MAIN STREET MASTER PLAN

Conceptual Design Phase

April 8, 2014

Conceptual 104' ROW Section from Industrial Blvd. to Broadway.
Proposed median shown is not continuous in corridor.

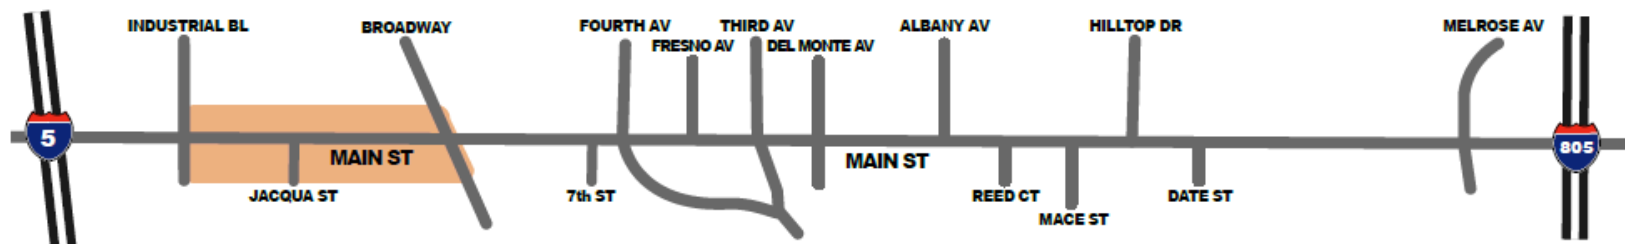
| 1) Very good, safer for pedestrians | 3) No island in middle of Main St. in front of 2585 Main, Leaf Sales Inc. (David Leaf) | 5) Get rid of the yield on the right turn. Takes away R.O.W. from pedestrians, put stop sign instead. | 7) A good idea. |
| 2) Island in front of Santa Fe Meats will block entrance. (Eric Estrada) | 4) BJ Reynolds Trucks etc | 6) Need 2 lanes going east for eliminating traffic back-up. Area plan needs to consider trucks & trailers. Why do pedestrians get walks? | 8) Why have pedestrian improvements in truck business areas? 100% of their business don't walk to their business!

Untrue public comment: people walk to bus stops, schools, businesses and the very Rec. Center that we're standing at now. |

Refined Design Alternative Segment 2 of 4

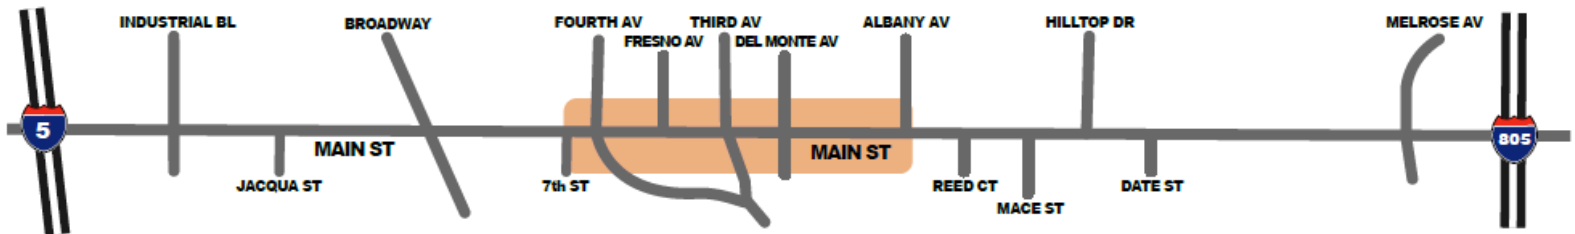
9) Roundabouts are not practical in this area.

10) I love the 7' bike lane w/ 2' buffer.

11) Oversized rigs

12) Recognize the Strawberry Fields w/ art.

13) Keep the roundabouts. Design them in a way that allow trucks to drive over them.

14) 5' bike lane looks good.

15) Roundabouts nice for Bird Rock, but NOT for here. Traffic will be an issue.

Conceptual 83'-6" to 90'-0" ROW Section from 7th St. to Albany Ave.
Proposed median shown is not continuous in corridor.

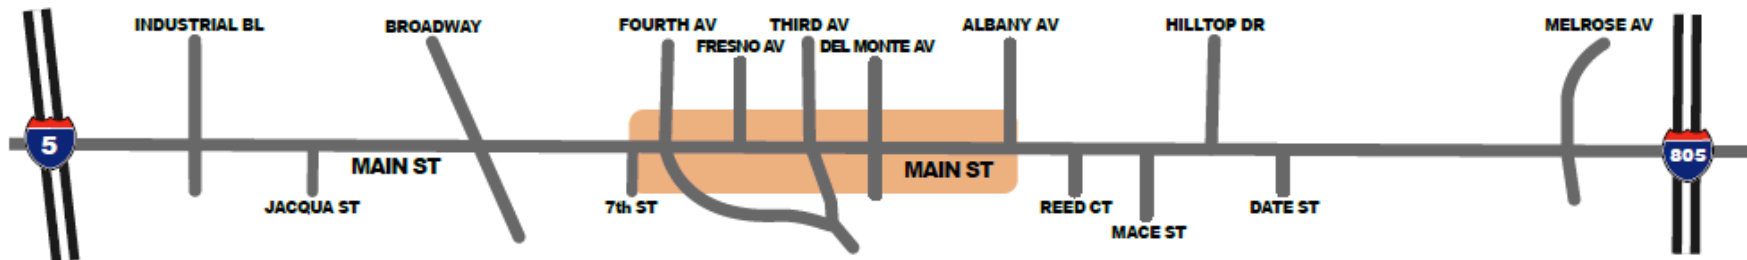
16) Increase street parking.

17) I like the painted buffers. The more buffers, the better. Consider pylon posts.

18) Double trailer access required.
(Kevin Marshall)

19) Looks good.

Conceptual 90' to 100' ROW Section from Date St. to Melrose Ave.
Proposed median shown is not continuous in corridor.

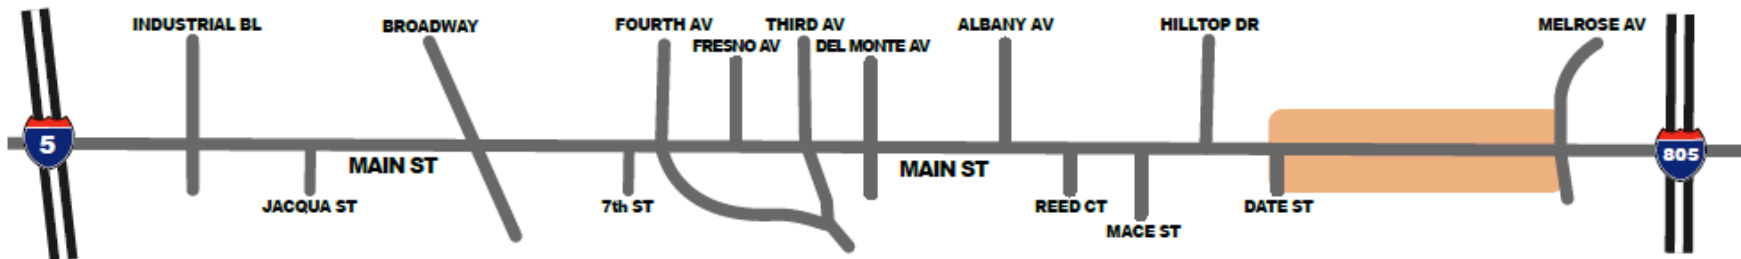
19) Looks good.

20) 11' wide lanes are TOO narrow for 12' wide loads. Safety issues.
